MISSISSIPPI POWER & LIGHT COMPANY

SUBJECT: Grand Gulf Nuclear Station
Units 1 and 2
Docket Nos. 50-416 and 50-417
File 0260/0862
Transmittal of Proposed FSAR
Changes and Responses to NRC
Questions
AECM-81/312

The following concerns regarding containment ultimate capacity were informally provided to Mississippi Power & Light Company based on the NRC's staff review of Appendix A to "Final Report on the Grand Gulf Nuclear Station Hydrogen Ignition System", transmitted in letter AECM-81/221, dated June 19, 1981.

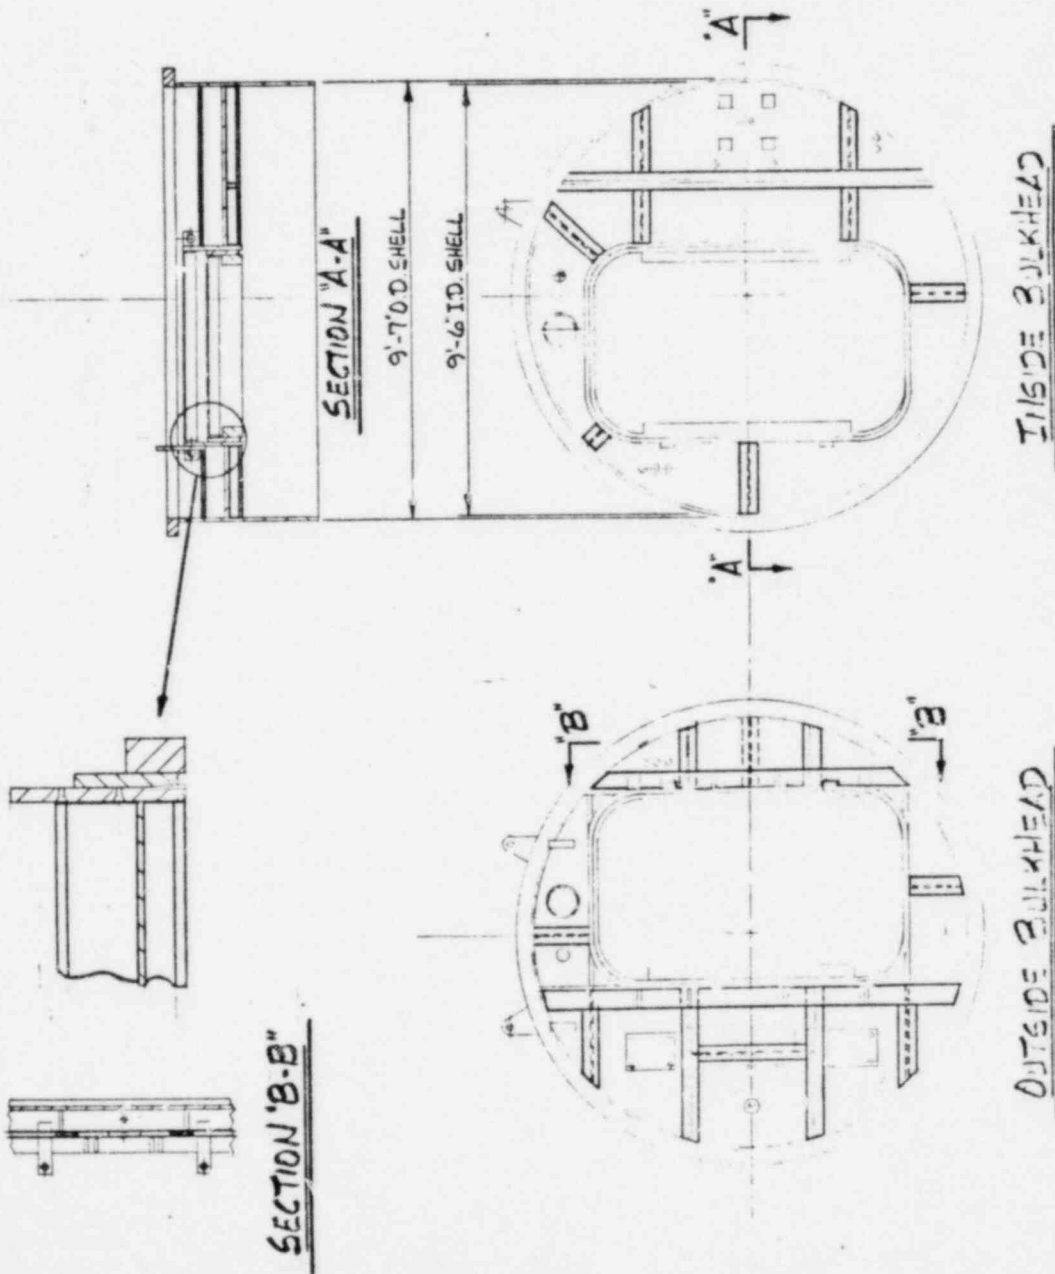
3. Indicate what consideration you have given in your analysis to the strain in the welds which connect the liner and the penetration, noting that they may constitute the leakage path.

The liner plate in the vicinity of the penetrations, reinforced to reduce the stress concentration effect of the opening, is attached to the penetration sleeve by full penetration groove weld. The use of E-70 low hydrogen series electrodes in the above welding results in a weldment which has strength and ductility characteristics comparable to the base material. Analysis of a major penetration (personnel lock) in the vicinity of maximum liner plate strains indicate that the subject weld will be well within the elastic limit and should not constitute a leakage path.

SECTION 'B-B'

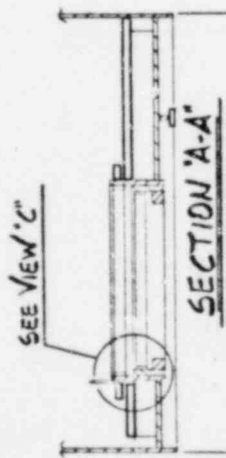
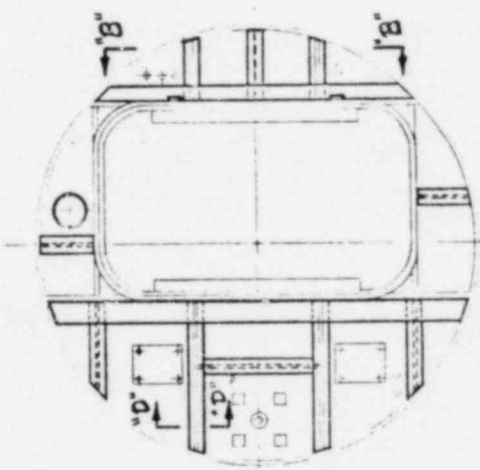
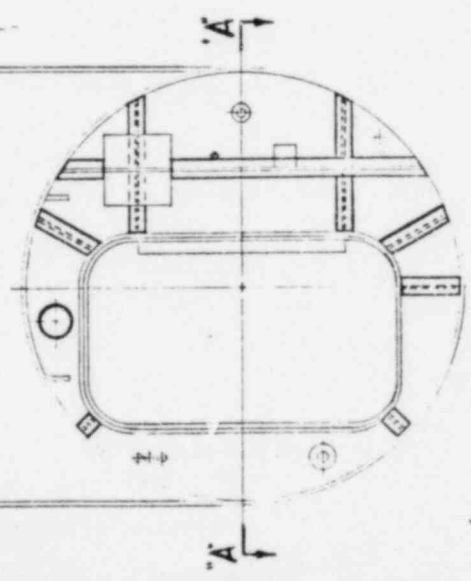
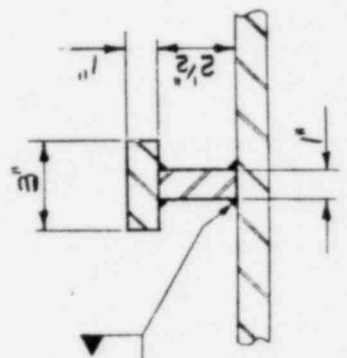
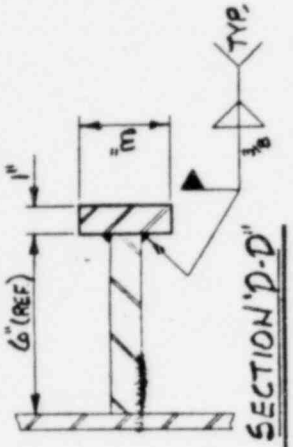
4. It is indicated that the upper containment air lock is to be strengthened to increase its pressure resisting capacity. Provide details with respect to the manner in which it will be strengthened.

The vendors analysis for the containment building personnel airlocks indicated that the bulkhead panels would yield at a pressure less than that calculated for hydrogen burn. In an effort to increase the capacity of the bulkhead panels, to be compatible with the pressure retaining capacity of the containment building, stiffeners are to be added to the bulkhead. The addition of these stiffeners will be completed prior to the time when the reactor core has accumulated sufficient power history to have the potential for a significant hydrogen release.

The stiffeners will be welded T-Sections fabricated from 1" thick steel plate and will have depths of 3½" and 7". The T-Sections will be welded to the bulkhead panels between existing stiffeners in order to increase the section modulus of the panels and reduce the overstress to allowable limits. All welding will be done in accordance with the ASME Code. See the attached sketches for definitive details.

The vendor's analysis for the airlock inflatable seals indicates that only a static differential pressure of 30 psi can be withstood. A detailed dynamic analysis will be conducted to determine the seals' capability to withstand the post hydrogen burn pressure profile.
